From: Bang The Table [admin@bangthetable.com]
Sent: Tuesday, 5 February 2013 1:00 PM
To: draftdcp
Subject: An anonymous user completed 'Submissions to the DCP'

Re: Consultation, Draft Randwick Comprehensive Development Control Plan (March 2013)

Figure 1: Drawing from page 32, "C3 Low density residential"

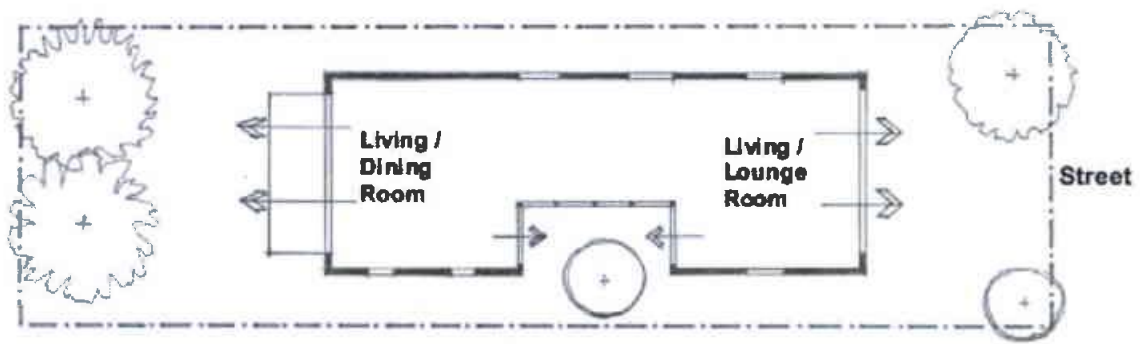
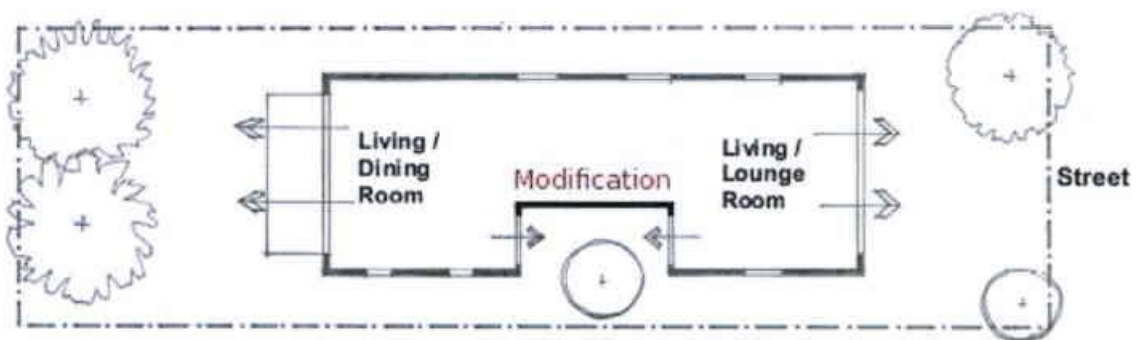
I would like to suggest that the preferred orientation figure shown on page 32 of the "C2 Low Density Residential" pdf file should be changed to indicate that having courtyard glass facing closely adjacent neighbours is NOT a preferred solution. Figure 1 on the following page shows the existing drawing; Figure 2 shows how I think it should be.

I am prompted to comment on this because the property adjacent to mine has exactly the design indicated in the current figure. Following the construction of the neighbours' DA last year, they are now able to view approximately 80% of my bathroom should the bathroom window be open to allow ventilation. Council planners agreed that no frosting need be placed on the glazing because the area behind the glazing was not a high use area. However the area is in continuous use because the house design narrows in that section and because that section connects top floor, bottom floor, front and back of the house. It has been a problem for me ever since the house next door was occupied, and the owners next door also cited lack of privacy in a subsequent DA.

In summary, I urge you to reconsider the freedom that the currently-drawn figure gives to overlook neighbours, by amending the figure.

Figure 2: Suggested modification to drawing from page 32, "C3 Low density residential"

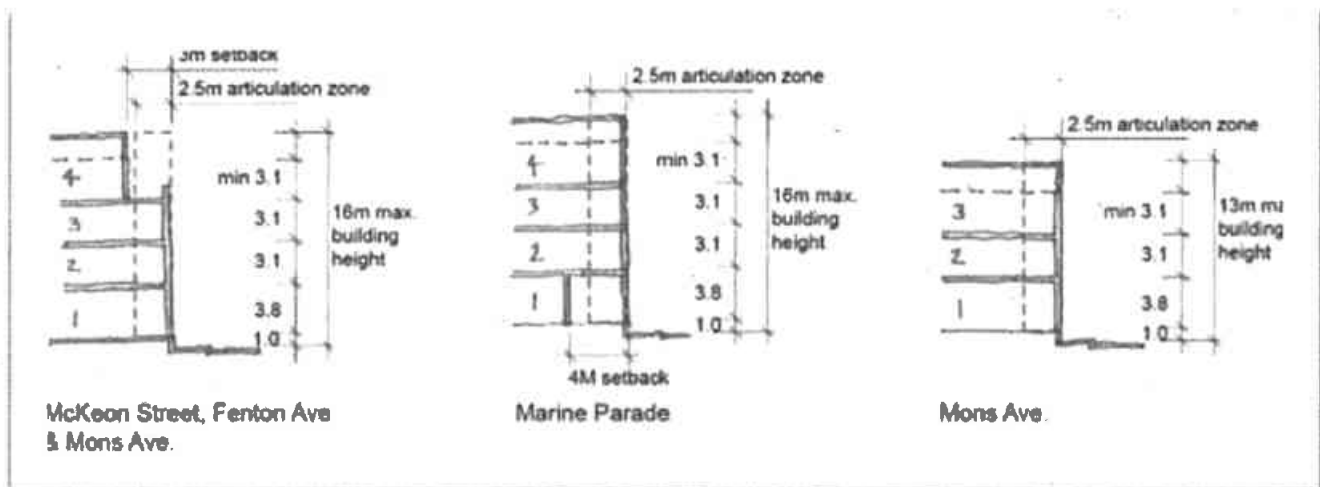
The DCP for Maroubra beach explicitly states in Figures 4 and 5 that the highest building heights can be along Marine Parade (16m) for both the Amalgamated Scheme and the Base Scheme, (*see pdf page 84 & 85*). This will allow a developer to create a cliff-like edifice along the entire length of Marine Parade, and over a good part of Fenton Avenue and McKeon St in both Schemes. There is no earthly reason why this should be allowed, and plenty of reasons why it should not be allowed, the first of which is that it will create a vastly expanded "Dead Zone" along Marine Parade, where the winter light never penetrates, and the cold southerly wind blows.

This is bad design of the worst kind, and I am very surprised that a reputable architectural firm would even suggest that this is a good idea, and that the Council would even think of allowing it, when the DCP states that upper level setbacks are necessary to limit overshadowing (*pdf page 89*), so why isn't there a series of upper level setbacks to limit the overshadowing on Marine Parade, and to enable a bit of winter sun to penetrate the "Dead Zone"? Many people in both Community Workshops last year stated expressly that they did not want "cliff-like edifices" along Marine Parade or anywhere else; it will make the place feel even darker and colder than it is now, claustrophobic, and canyon-like, very unlike the sense of openness that currently contributes to the unique seaside character of Maroubra beach.
